ADDENDUM NUMBER TWO (21)

Project: Liberty Park Renovation – Re-Bid
Liberty Park Sports Complex
Madison, MS
PN: 22095

FROM: Dean Architecture, P.A.
661 Sunnybrook Road, Suite 140
Ridgeland, MS 39157
(601) 939-7717

A100

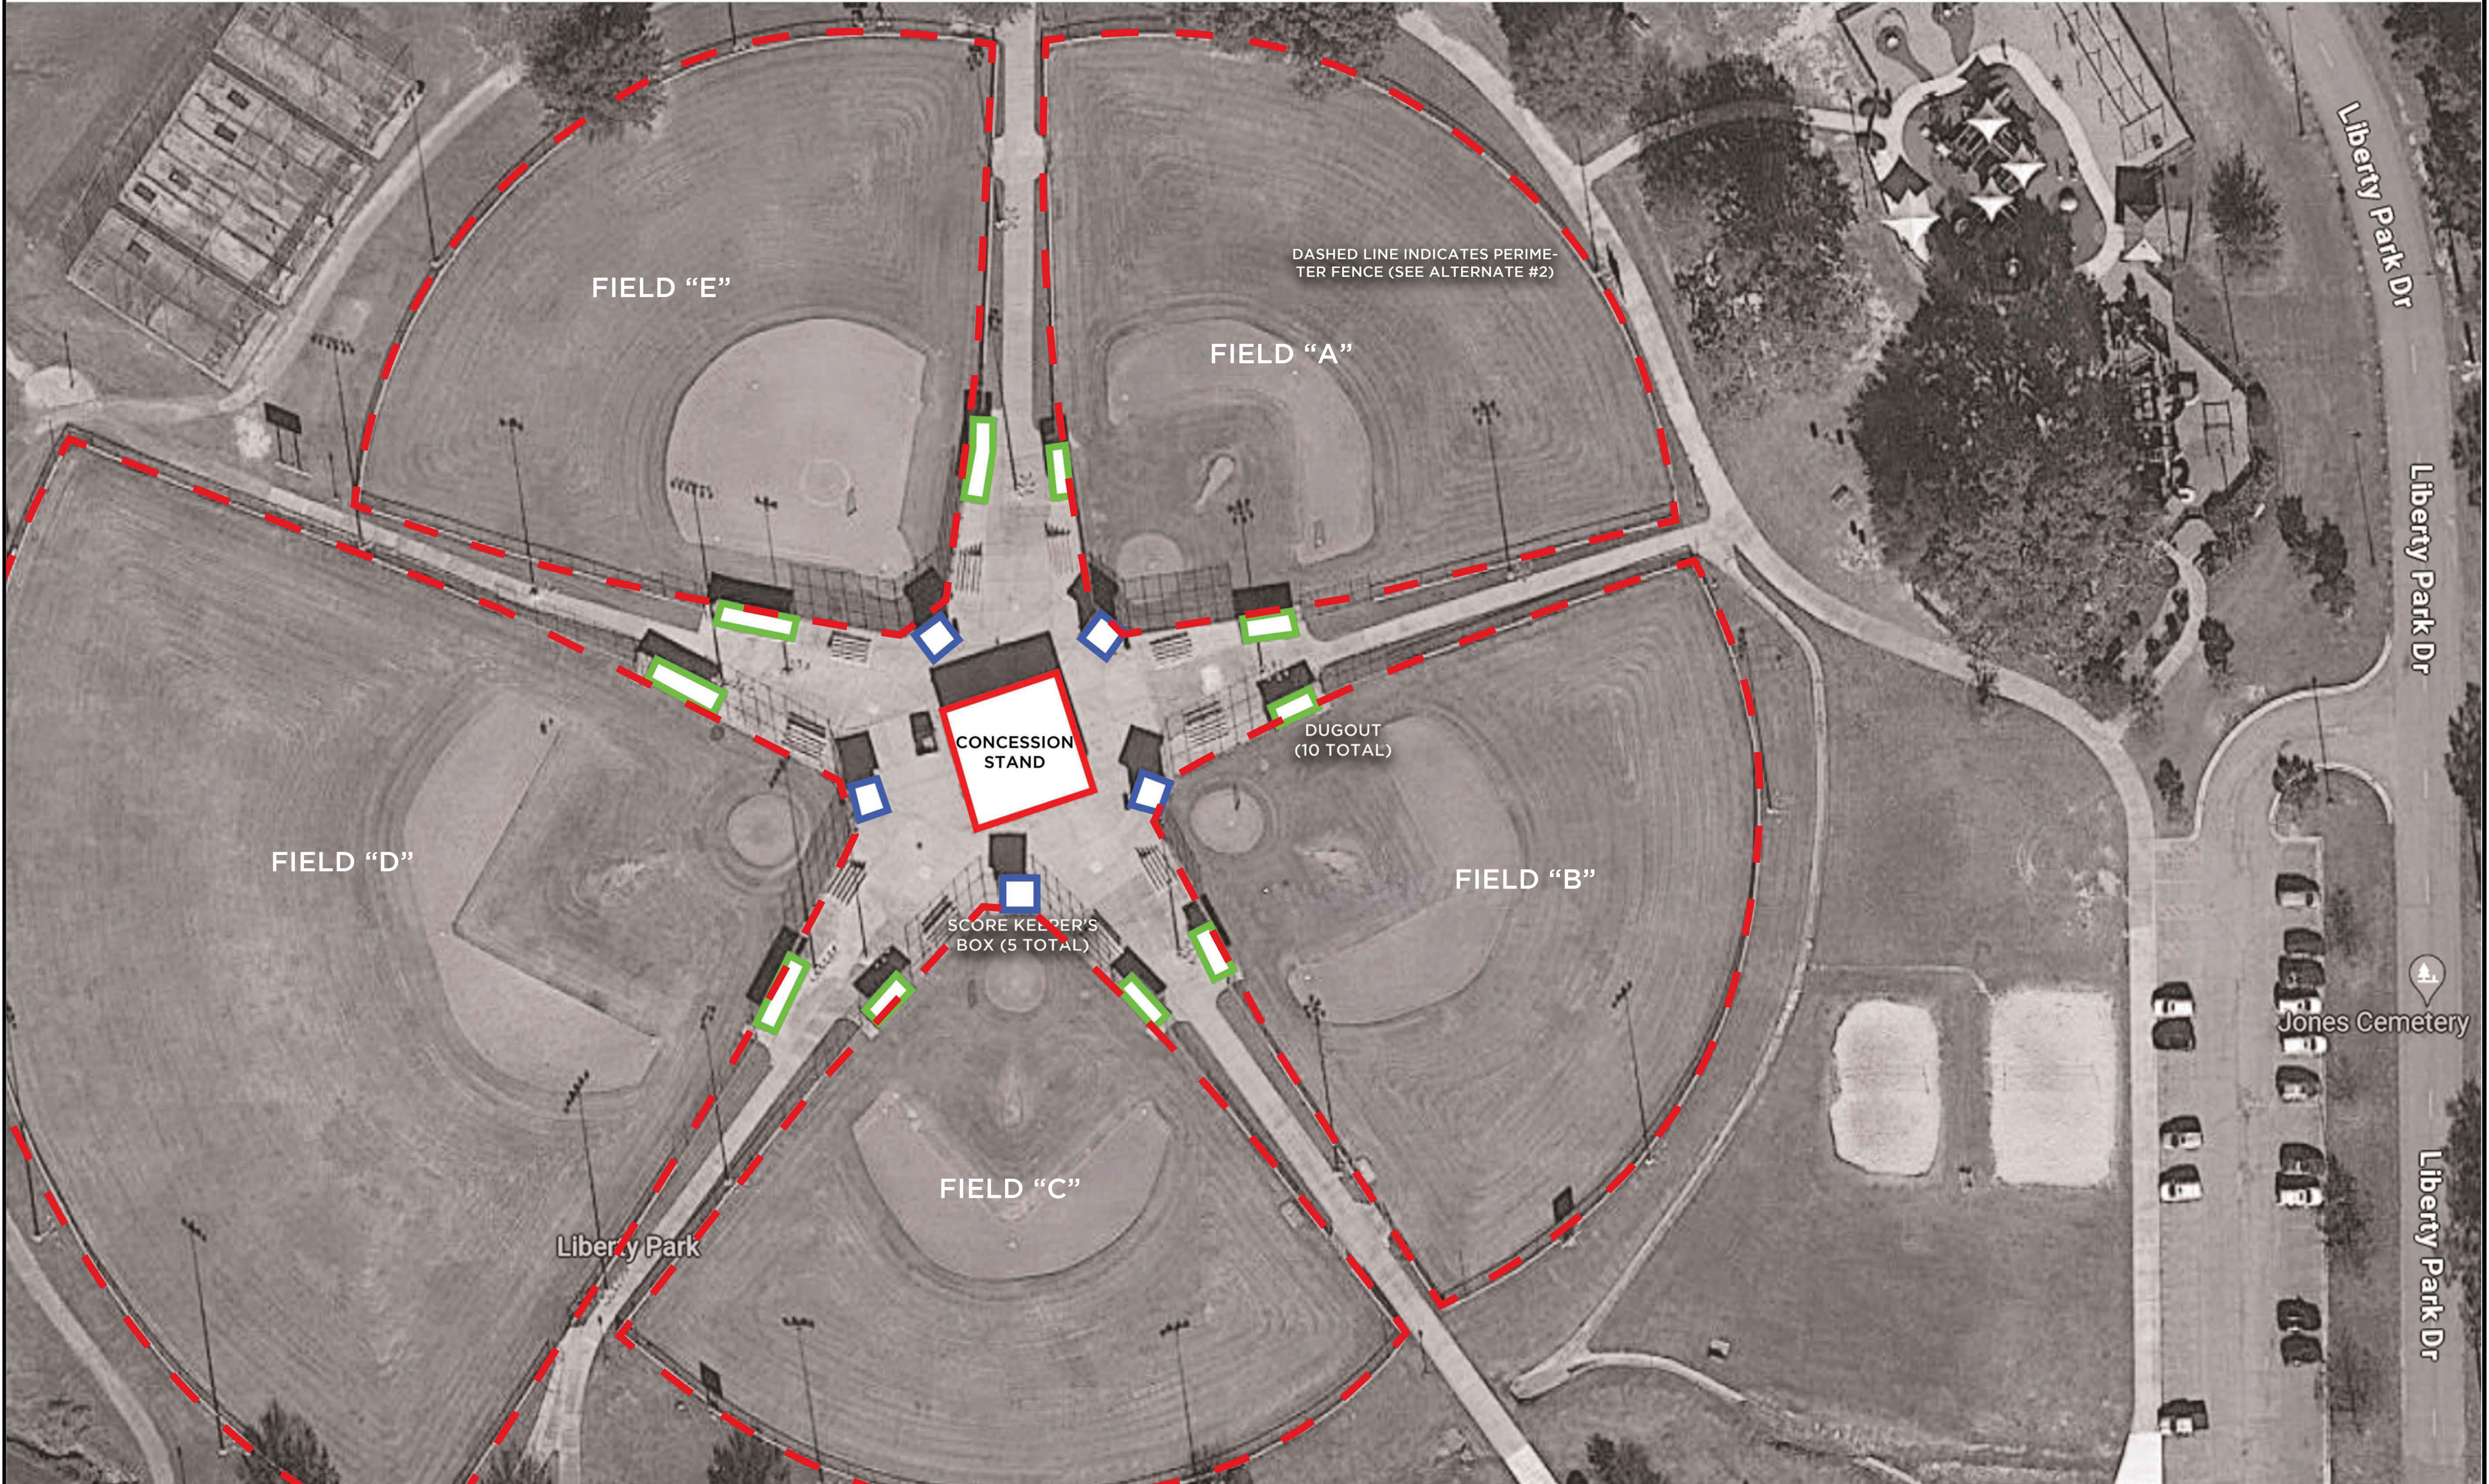
- Item #4:** Provide a unit price for plywood decking to be replaced.
- Item #5:** Backstop netting is to be provided and installed by the Owner.
- Item #6:** Updated A100 Site Plan showing Field names that corresponded to Field names listed in Addendum #1.

Item #1: Sheet A100, as follows:

Replace in its entirety
